**RESPONSE TO COMMENTS/FINAL DECISION DOCUMENT  
EPA REGION 6**

**Final Administrative Order (Order), Docket No. RCRA-VI-002(h)-95-H, pursuant to Section 3008(h) of the Resource Conservation and Recovery Act (RCRA), 42 U.S.C. §6928(h)**

**Altus Air Force Base  
Altus, Oklahoma  
OK9571824045**

**Figure 2: A 3-Dimensional Schematic of a Bio-Mulch Wall**

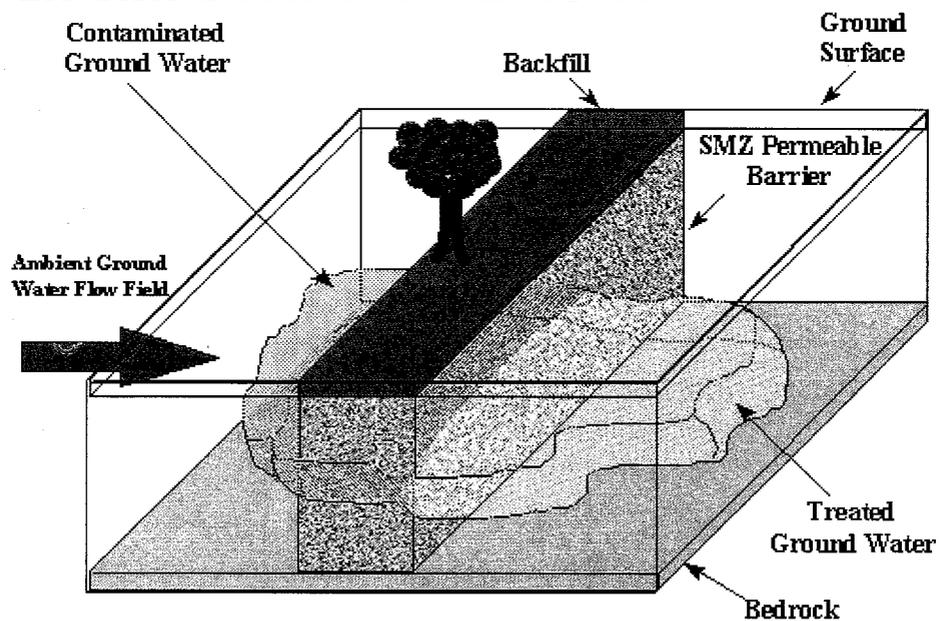
Dr. John Wilson, from the EPA National Risk Management Laboratory in Ada, Oklahoma made the comment that the mulch biowalls should not be referred to as "bark mulch biowalls" as used in the Statement of Basis document. The terminology is now changed to "bio-mulch walls".
